Product Change Notification

PCN-ICC-9099-2023

Business Unit	Product Line Code	Type of Change	Action	Date of Issue
ICC - Industrial Cabinet	BE1	Product Change Notification	Notify Distributors and Field	10/18/2023

Previous Product	New Product
OLD  OLD 	NEW  NEW

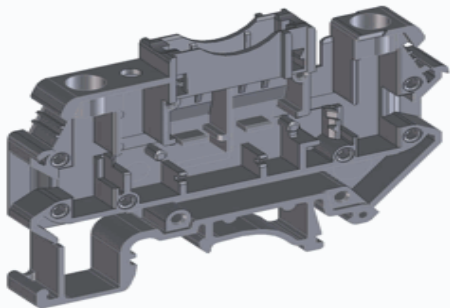
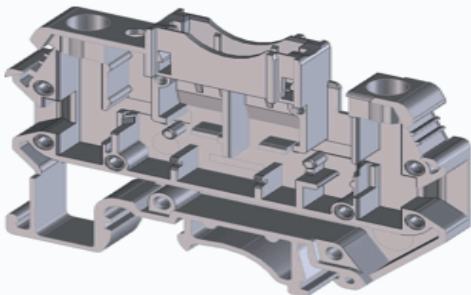
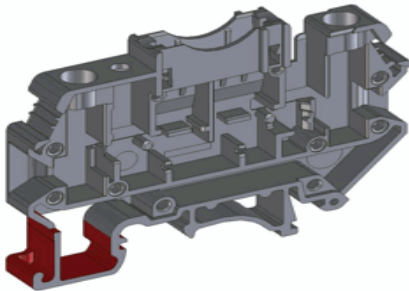
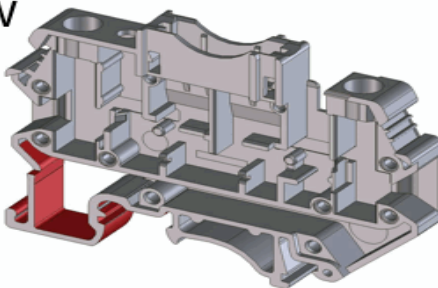
Modification of the foot geometry to improve the mounting process on the DIN rail in terms of forces and haptics. The change will have no impact on the products functionality. Overall dimensions of the product will not be impacted by this change.
